32655/L/003G/RJM/rjm

**BASEMENT IMPACT ASSESSMENT – ADDENDUM  
13 FERNCROFT AVENUE, NW3 7PG**

Further to the Audit undertaken by LBH Wembley of our Basement Impact Assessment (BIA), Letter Reference LBH4324, dated March 2015, and subsequent correspondence and telephone conversations, we are pleased to submit this Addendum to the BIA which, along with the attached appendices, addresses the points raised by the audit.

<b>KNAPP HICKS AND PARTNERS LTD.</b> CONSULTING ENGINEERS Prospect House, 1 Highpoint Business Village Henwood, Ashford, Kent TN24 8DH Tel: +44 (0) 1233 502255	Drn.	CCG
	Date	25/09/2015
	Scale	1:100 @ A3
	Drawing No.	Rev.
	32655T-01	A

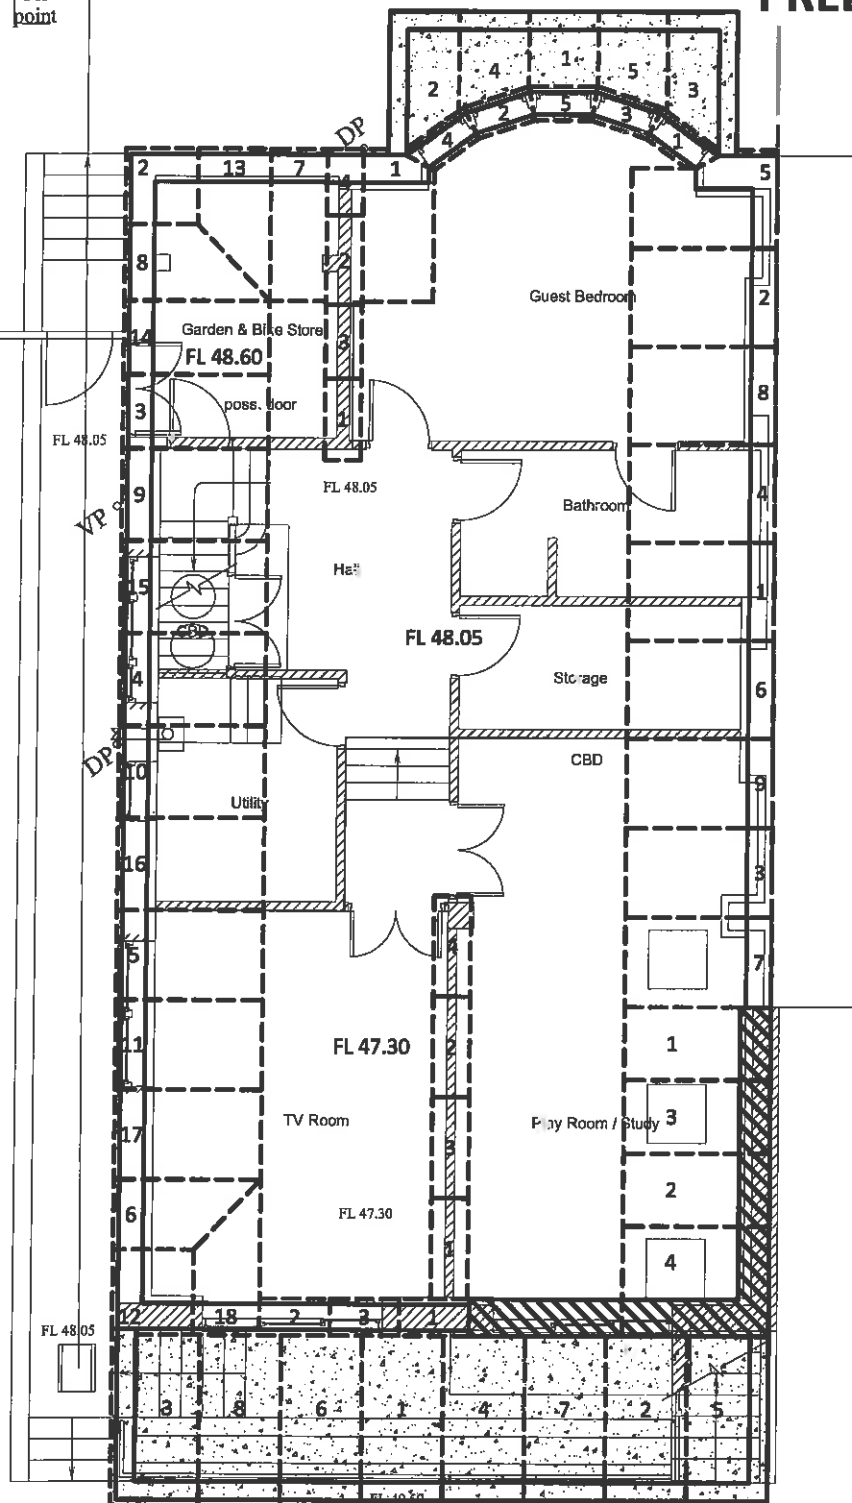
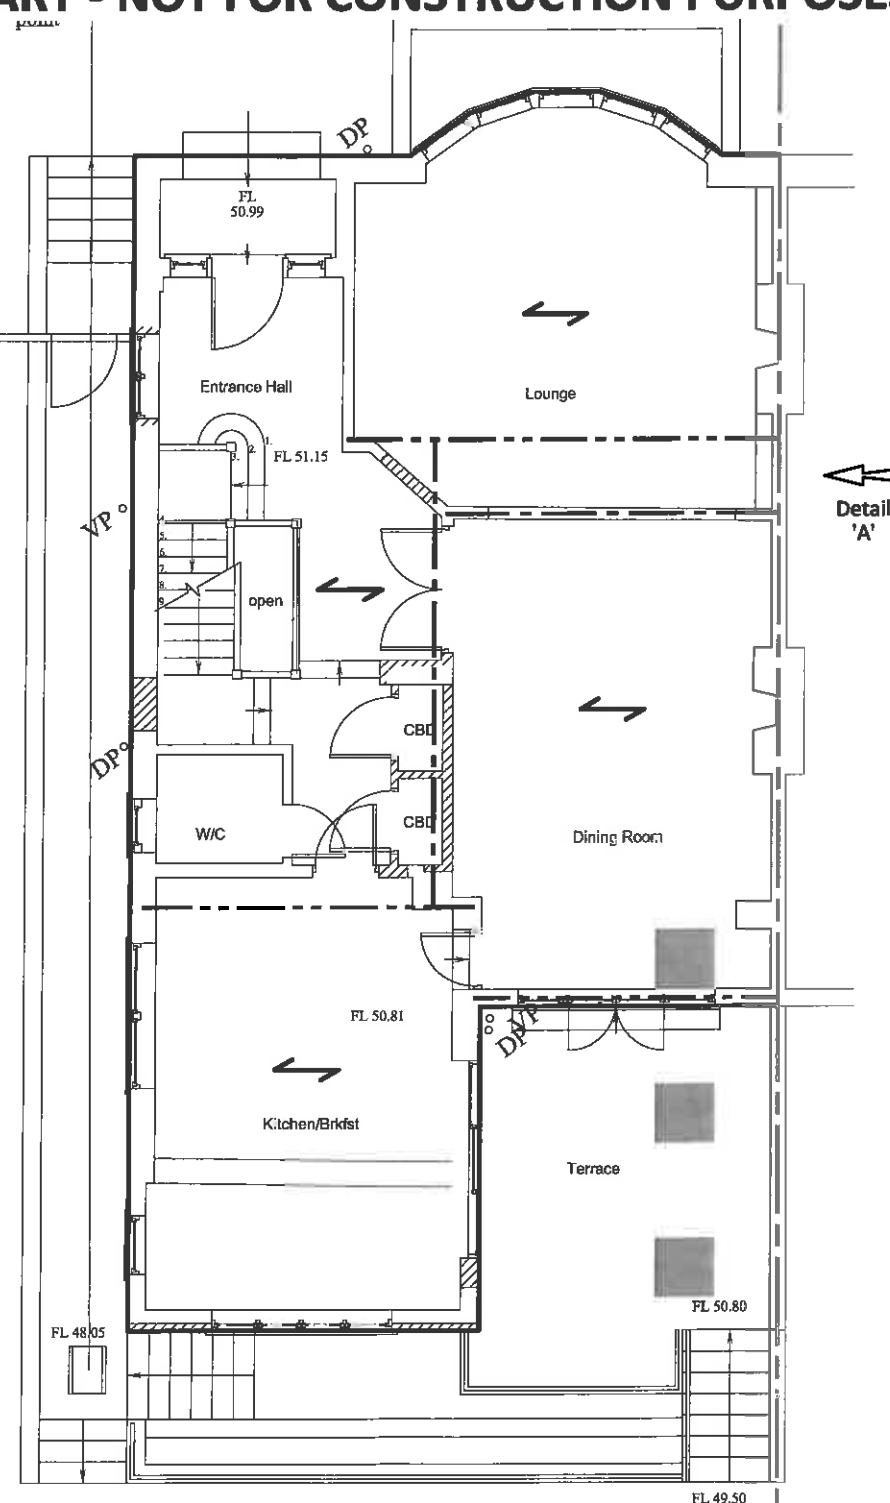
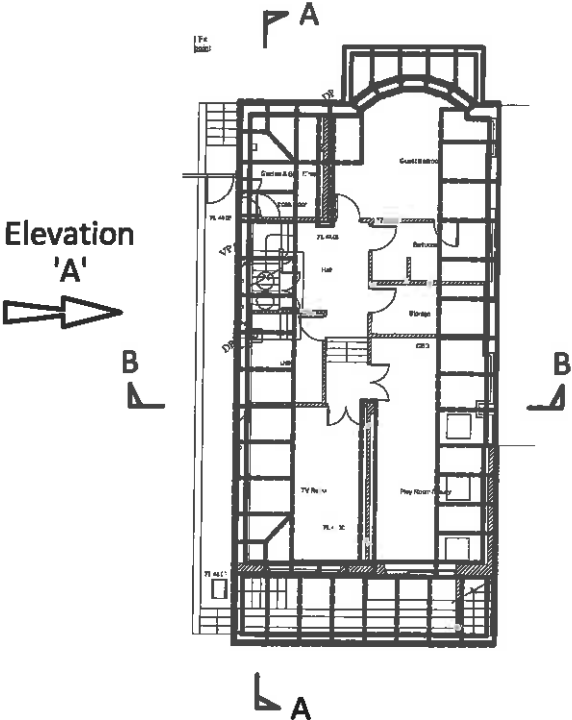
We refer you to the attached preliminary structural engineering drawings, Ref 32655T-01 to 04, dated 29/9/2015. In particular Drawing 32655T-01 which includes Basement and Ground Floor Plans showing the proposed foundation arrangements, and detailed notes which cross-reference to the BIA and related specialist reports, and provide a sequence of works. These drawings are preliminary only and are not intended for construction purposes.

- D) Excavate 3 no. underpin locations marked '1' on foundation plan - to the front lightwell retaining wall, left party wall underpin legs and rear lightwell retaining wall. Then assess in accordance with Item 5.3.2 of the Hydrogeological Desk Study and confirm dewatering method to be employed.
